# **Appendix E**

## **Expert Advice**

## PLAN CHANGE 6: REGULATORY EFFECTIVENESS AND EFFICIENCY PROGRAMME (REEP) – TRANSPORTATION SUBMISSIONS

**Figure 2: Extract from LASS RITS D3.1.1**

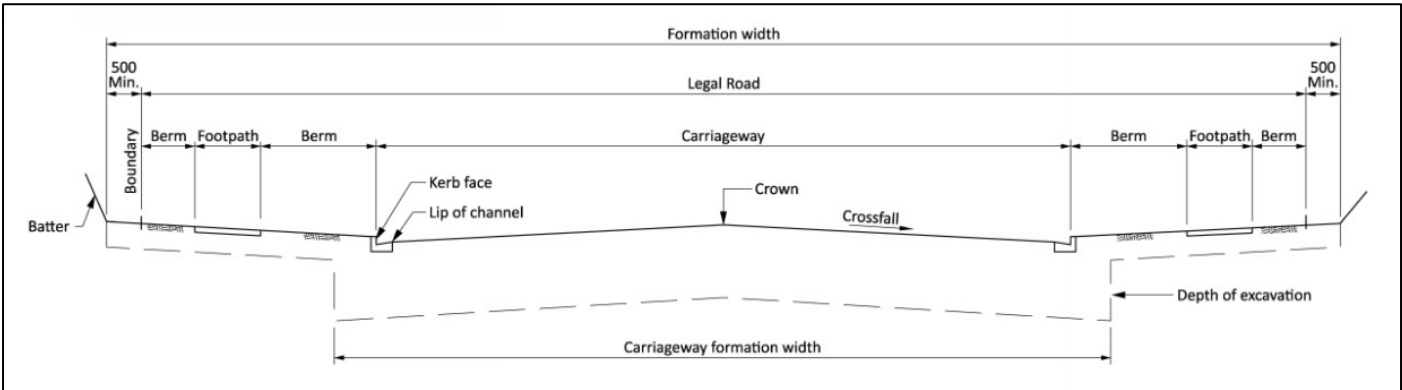
The District Plan currently requires a 6m carriageway width for all residential local roads while NZS4404 provides for a movement width of 5.5-5.7m (excluding shoulders). For clarity, the RITS (D3.1.1) defines the carriageway as the width from kerb face to kerb face. This is consistent with Austroads guidance<sup>3</sup>. This is important as recently constructed subdivisions include a modified kerb profile in parking bays/vehicle crossings which has reduced the effective width of the parking bays.

In discussing the requirements for carriageway widths NZS4404 (C3.3.1) states that:

*“A width in the range of 5.5-5.7m providing for ability to park on one side of the road and one through lane, or alternatively two through lanes. This is often not defined at engineering stage and is instead left to road users to choose this type of road is provided for in the standard and is typically appropriate for shorter streets up to approximately 250m, to assist with achieved a slower operating speed.”*

The District Plan (Rule 23.7.3a)) requires a minimum transport corridor boundary of 15m for a front site. A 250m long road would provide for 16 lots on each side of the roads (32 lots total). We note that the threshold for carriageway widths is set at 20 lots. We recommend that the carriageway width for Local (low volume) transport corridors is retained at 6m.

Local residential roads with more than 20 lots are likely to be longer than 250m and we support retaining a 6m carriageway width.
